# UNITED STATES PATENT AND TRADEMARK OFFICE

APPLICATION NO.	FILING DATE	FIRST NAMED INVENTOR	ATTORNEY DOCKET NO.	CONFIRMATION NO.
10/759,920	01/16/2004	Shirley Wang	12283/13	1514
26646	7590	07/26/2004	EXAMINER	
KENYON & KENYON ONE BROADWAY NEW YORK, NY 10004			KATCHEVES, BASIL S	
			ART UNIT	PAPER NUMBER
			3635	
DATE MAILED: 07/26/2004

## Office Action Summary

### **DETAILED ACTION**

**Fig. 8**

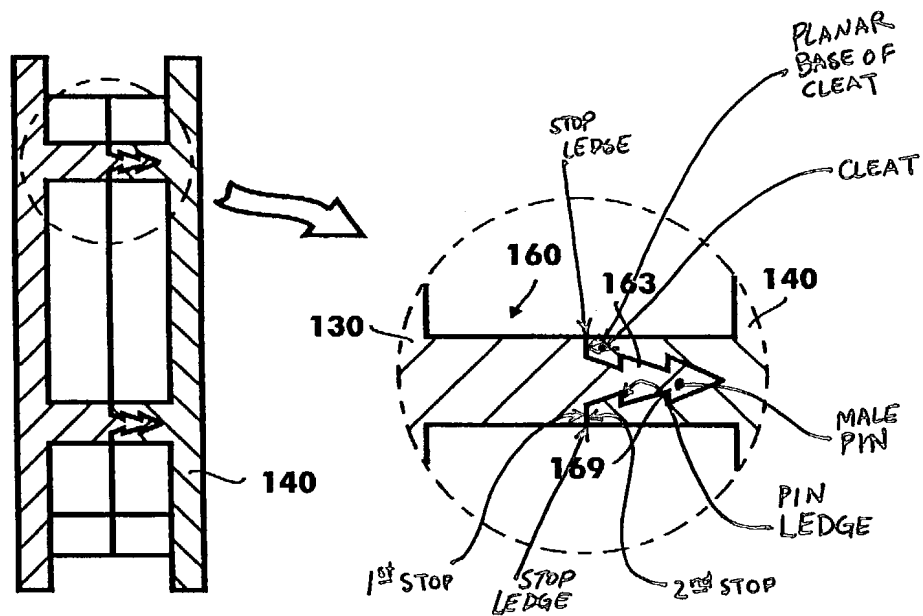
Regarding claim 13, Suh discloses a frame assembly (fig. 1: 100) for retaining a window (fig. 2: 120) in a door (fig. 1: 20) comprised of two frame members having screwless interlocks (fig. 8: 160 & 140). Suh discloses a first frame member (fig. 8: 160) and a second frame member (fig. 8: 140) having a stop (marked fig. 8) to prevent over insertion.

Regarding claim 14, Suh discloses the first interlock (fig. 8: 160) as being male and the second interlock (fig. 8: 140) as being female with a stop (marked fig. 8) which prevents over insertion.

Regarding claim 15, Suh discloses the stop as being part of the first interlock (marked fig. 8).

Regarding claim 16, Suh discloses the stop as being part of the second interlock (marked fig. 8).

Regarding claim 18, Suh discloses the stop (marked fig. 8) as being integrally formed as part of the first screwless interlock.

Regarding claim 20, Suh discloses the second screwless lock (fig. 8: 140) as having the stop (marked fig. 8) integrally formed.

Regarding claim 21, Suh discloses the first interlock as being a pin (fig. 8: 163) with extending ledges (marked fig. 8).

Regarding claim 22, Suh discloses the stop as having a ledge (marked fig. 8) which extends from the pin.

Regarding claim 23, Suh discloses the stop (marked fig. 8) as engaging an outer surface of the second interlock (marked fig. 8).

Regarding claim 24, Suh discloses an interlock comprised of a pair of pins (fig. 8: see left diagram with pair of pins).

Regarding claim 25, Suh discloses the stop as comprised from a pair of ledges (marked fig. 8) extending from the pins.

Regarding claim 26, Suh discloses the second interlock (fig. 8: 140) as having a pair of cleats (marked fig. 8).

Regarding claim 27, Suh discloses the interlocks as having two cleats (marked fig. 8).

Regarding claim 28, Suh discloses the stop as planar (marked fig. 8) and extending between bases of the cleats.

Regarding claim 30, Suh discloses the first interlock (fig. 8: 160) as integrally formed with the frame and includes a pair of pins (fig. 8: left diagram), each pin having a pair of horizontal ledges (marked fig. 8) extending from the pin. Suh also discloses a second interlock (fig. 8: 14) formed as part of the frame and having a double cleat (marked fig. 8) with a planar base extending between cleats (marked fig. 8).

Regarding claim 32, Suh discloses the first interlock (fig. 8: 160) as integrally formed with the frame and includes a pair of pins (fig. 8: left diagram), each pin having a pair of horizontal ledges (marked fig. 8) extending from the pin. Suh also discloses a second interlock (fig. 8: 14) formed as part of the frame and having a double cleat (marked fig. 8) with a planar base extending between cleats (marked fig. 8).

Regarding claim 34, Suh discloses the first interlock (fig. 8: 160) as integrally formed with the frame and includes a pair of pins (fig. 8: left diagram), each pin having a pair of horizontal ledges (marked fig. 8) extending from the pin. Suh also discloses a second interlock (fig. 8: 14) formed as part of the frame and having a double cleat (marked fig. 8) with a planar base extending between cleats (marked fig. 8).
